Recall Bulletin

PRODUCT SAFETY RECALL

SUBJECT: Loss of Power Brake Assist in Extreme Cold Weather

MODELS: 2009-2010 Pontiac Vibe
With 1.8L Engine (RPO LAY)
Registered in Canada, Alaska, Colorado, Idaho, Illinois, Iowa, Kansas,
Maine, Michigan, Minnesota, Montana, Nebraska, Nevada, New
Hampshire, New York, North Dakota, South Dakota, Vermont, Wisconsin,
Wyoming

2327256

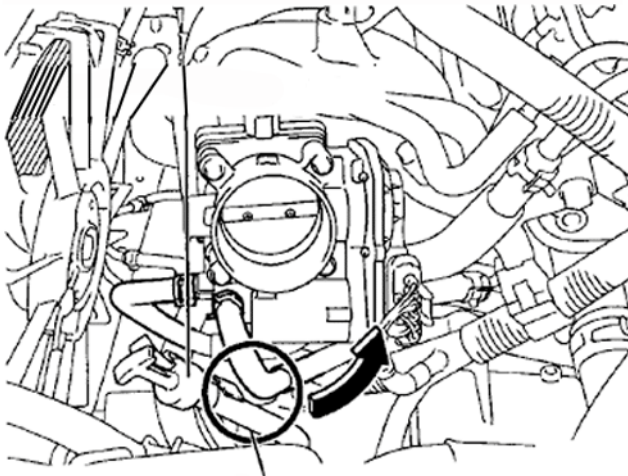
Note: Ensure that the air intake connector is properly aligned with the throttle body by pulling upward on the air intake connector hose fitting while tightening the bolts. Failure to do this may result in a whistling noise during light throttle application.

Note: To ensure a tight seal with the gasket, pull up on the intake air connector as illustrated.

8.5. While pulling up the intake air connector, tighten the 4 bolts to 10 N·m (89 lb in).
